Vibration

EVS-GTR 17th

China
2019.01

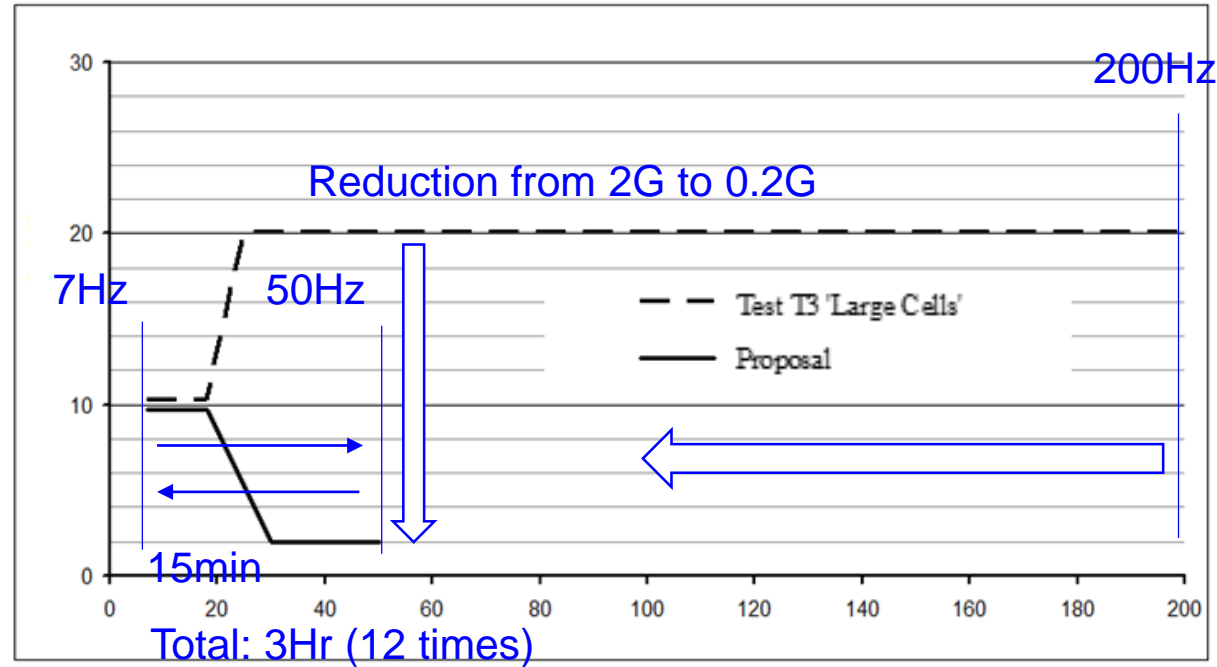
■ Is vibration in EVS-GTR No.20 reasonable?

- UNR100 requires twelve times of 15-minute amplitude sweep from 7Hz to 50Hz. Why can it guarantee the durability over the vehicle service life? Does one 15-minute sweep represent one year vehicle driving? What is the rationale?
- 2G was reduced to 0.2G, 200Hz was reduced to 50Hz and three vibration directions were changed to one. What is the rationale for these changes? Is it based on actual vehicle test data? What are the test conditions and test results?

□ Sinusoidal vibration profile has only one acceleration value on each frequency.

- It differs from real world vehicle conditions. If an acceleration more than 0.2G occurs at a frequency higher than 30Hz in real world situations, the sinusoidal vibration profile is not appropriate for the evaluation.
- For the real world vehicle operation conditions. Each frequency has a certain range of acceleration values calculated based on probability distribution. The peak value may be higher than the sinusoidal vibration though it occurs less frequently.

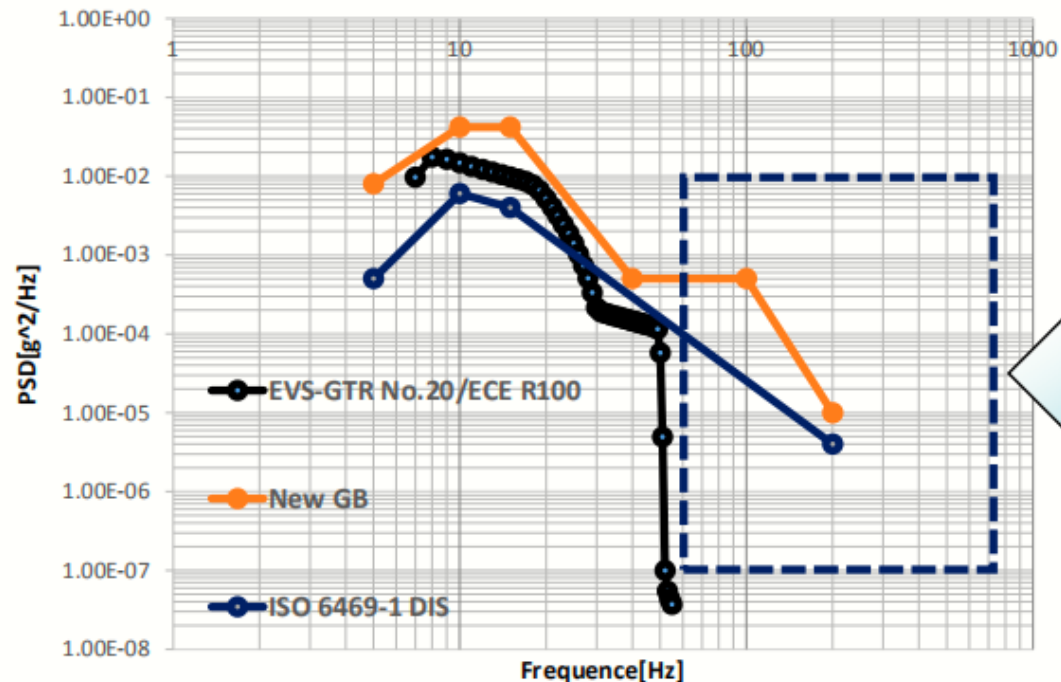
- Convert the GTR profile into PSD (12h, based on fatigue damage equivalence principle) and do the comparison in the same figure. (GTR PSD/GB/ISO6469)

Main difference:
There are no load strength where the frequency is higher than 50Hz in EVS GTR vibration profile.

- ISO6469 and new GB profile are all obtained from real vehicle measurement statistical data;
- So **frequency range** of EVS GTR vibration profile can not cover all vibration load in reality.

Dominant frequency: 60Hz

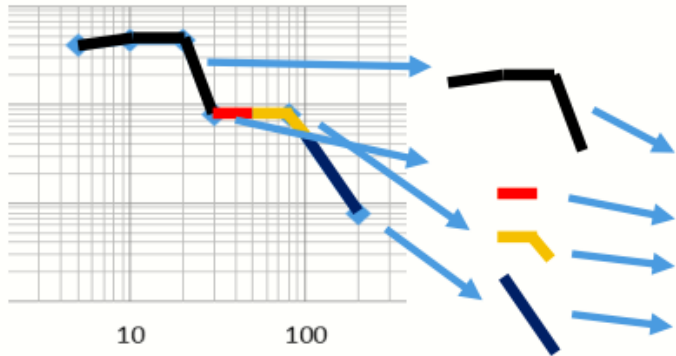
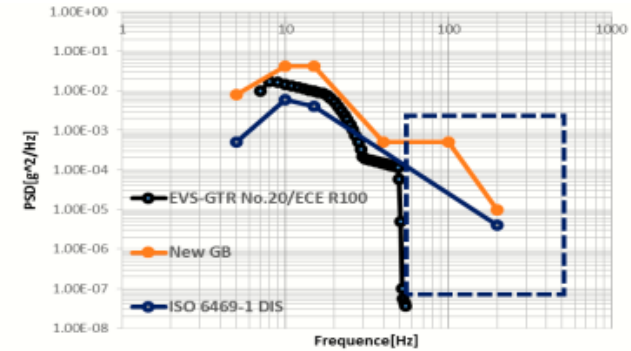
■ It's PSD around the dominant frequency that really work

- Dominant frequency section contribute most of the fatigue damage
- Vibration with frequency range below 50hz can not expose design defect of pack whose dominant frequency is higher than 50hz.

■ Several examples of pack design and their dominant frequency

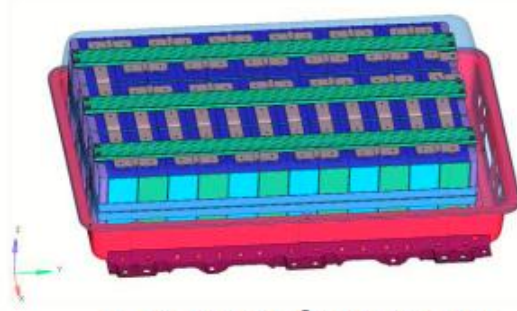
- There are lots of pack design whose dominant frequency is higher than 50Hz especially for PHEV and HEV.
- It is very hard for current EVS GTR vibration profile to expose these pack's design defect.

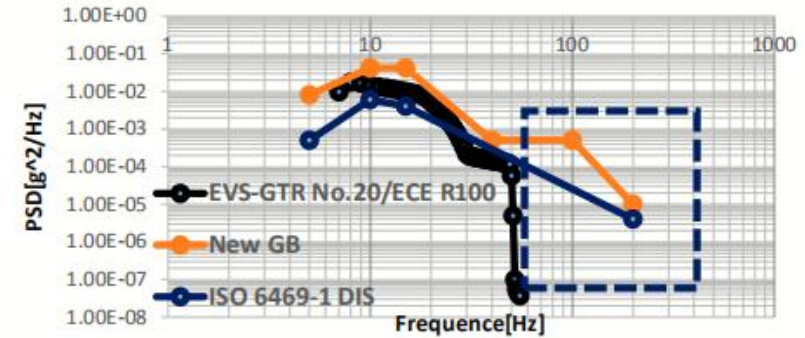
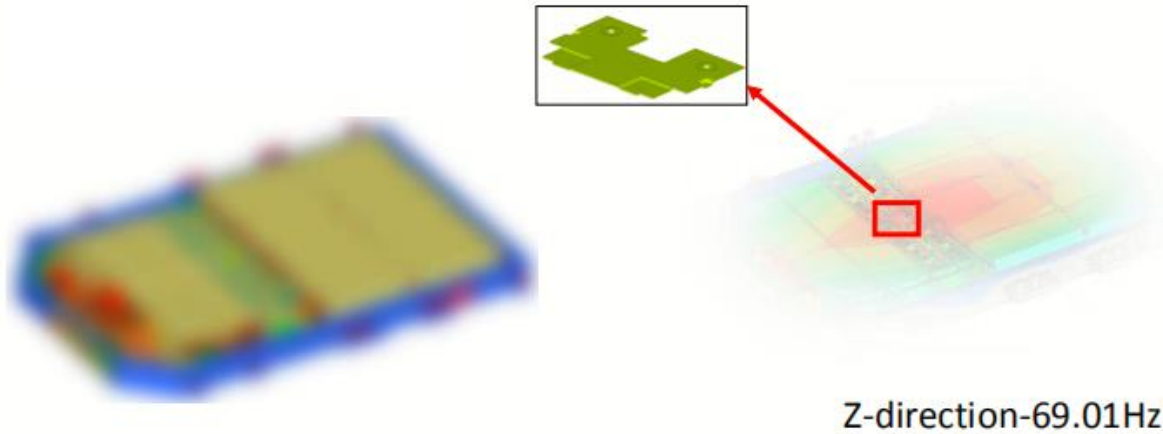
Conclusion	According to the simulation results:		
	<ul style="list-style-type: none"> ➤ EVS-GTR No.20/ECE R100: Bus bar passed; ➤ New GB(Section that below 50Hz): Bus bar passed; ➤ New GB(200Hz): Bus bar failed; 		
Results	Work Condition		Max. 3σ Stress(MPa)
			Bus bar (Al1060-O)
	EVS-GTR No.20/ECE R100	Z	9.68
	New GB(Section that below 50Hz)	Z	16.41
	New GB(200Hz)	Z	30.24

➤ EVS-GTR and section of New GB below 50Hz can not expose the design defect of pack whose dominant frequency is higher than 50Hz, if this design defect can lead to bus bar fatigue failure, then will cause safety problem.

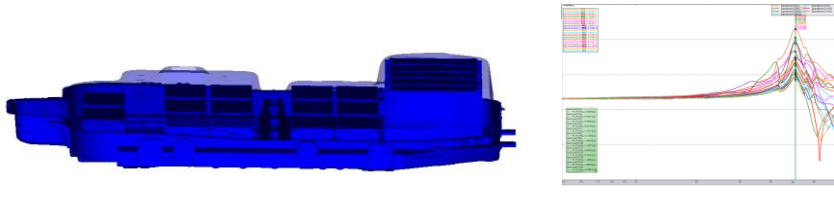
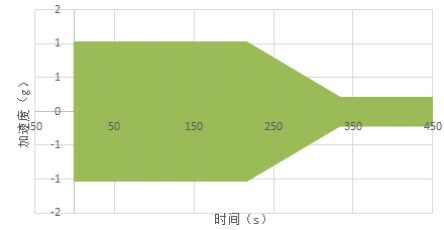
- The damage of road spectrum is much larger than that of GTR
 - One example

Condition	Damage
From road spectrum	9.655×10^{-4}
GTR	1.527×10^{-6}
